Certificate of Appropriateness Application

BAR # 22-09-04

0 3rd Street NE, TMP 330020001

Project: New residence on vacant lot

CONCEPTUAL PLANTING PLAN
 1" = 10'-0"
 NEW RESIDENCE FOR
 SCOTT LOUGHREY
 0 THIRD ST. NE
 FOR BAR MEETING 12/20/2022

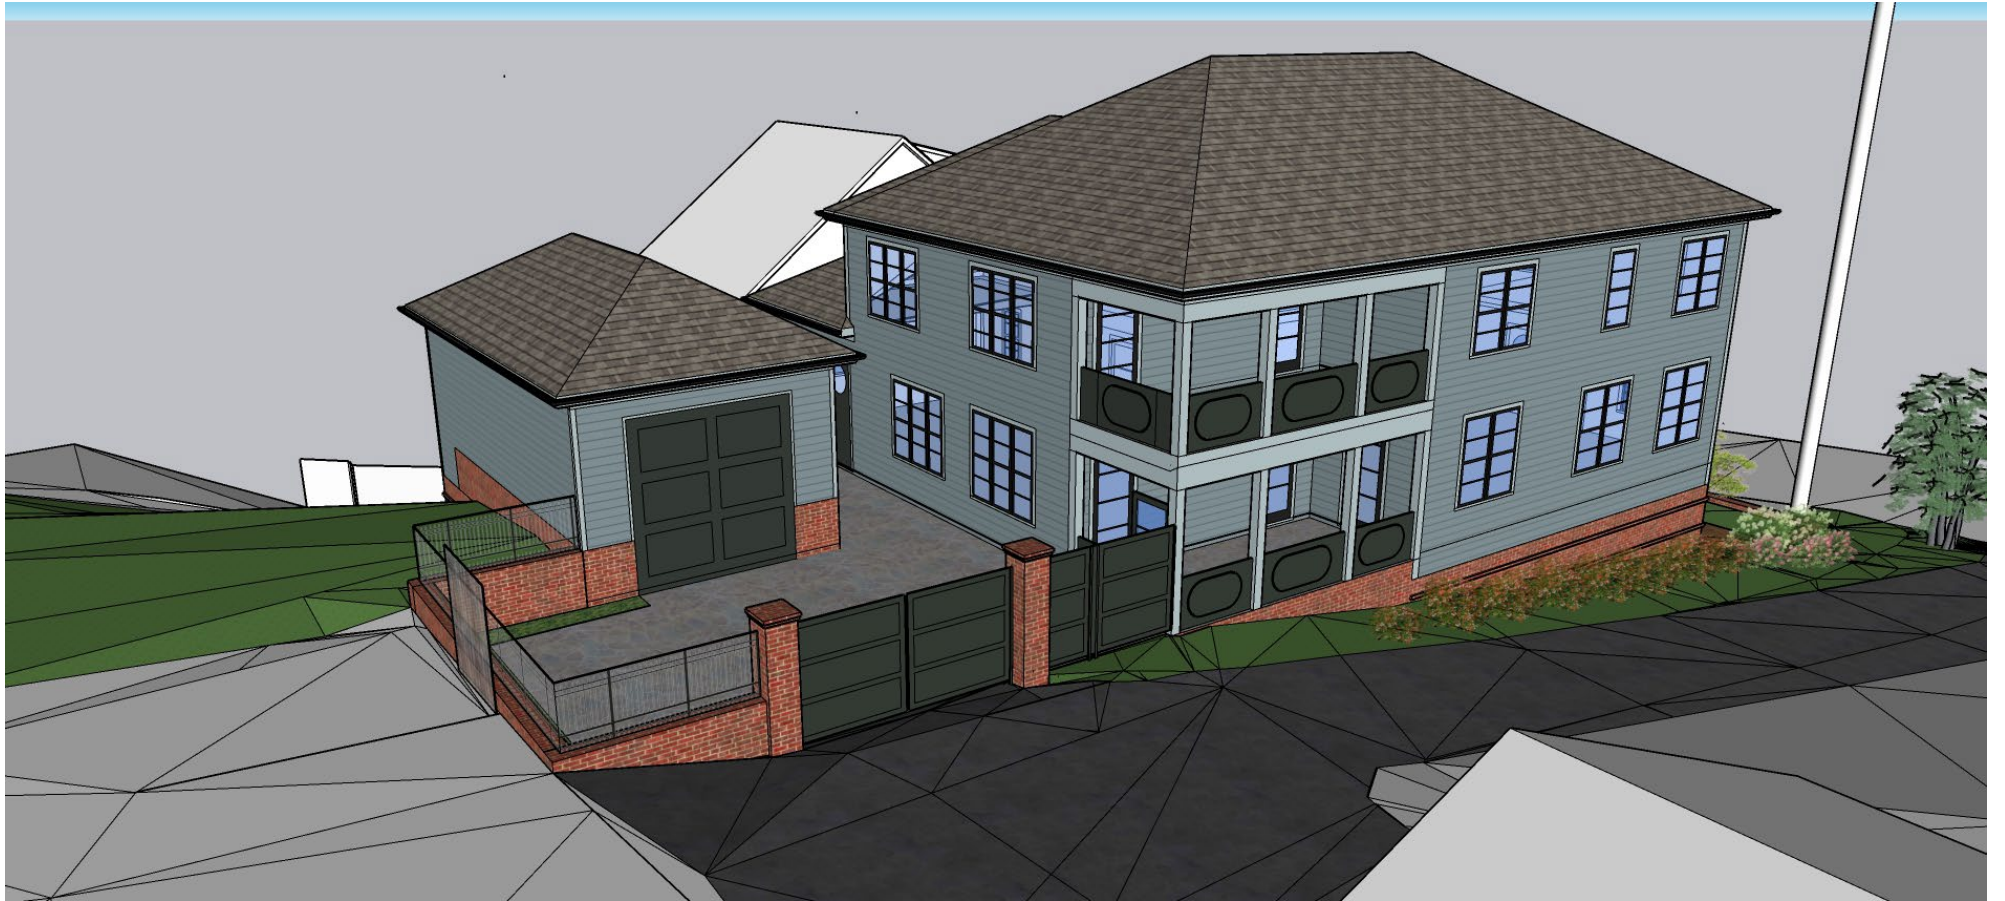
Note the revision below to the liriopse selection.

- *Liriopse Muscari* will be substitute for the *Liriopse spicata 'Big Blue'* indicated on the Landscape Plan. [Staff: *Liriopse spicata* is noted as invasive by the City of Alexandria and Arlington County. (www.invasiveplantatlas.org/subject.html?sub=11562) From the applicant’s note to staff: *Liriopse spicata* is a running type of liriopse and could spread, although the brick walls will contain it. However, *Liriopse Muscari* is a non-running, "clumping" variety that will not travel outside the brick walls. There are a couple varieties of *muscari*; the client will select one of those variants.]

Mr. Zehmer moved: Having considered the standards set forth within the City Code, including the ADC District Design Guidelines, I move to find that the new residence at 0 3rd Street, NE satisfies the BAR's criteria and is compatible with this property and other properties in the North Downtown ADC District, and that the BAR approves the application as submitted with the alternate lirioppe noted in the staff report.
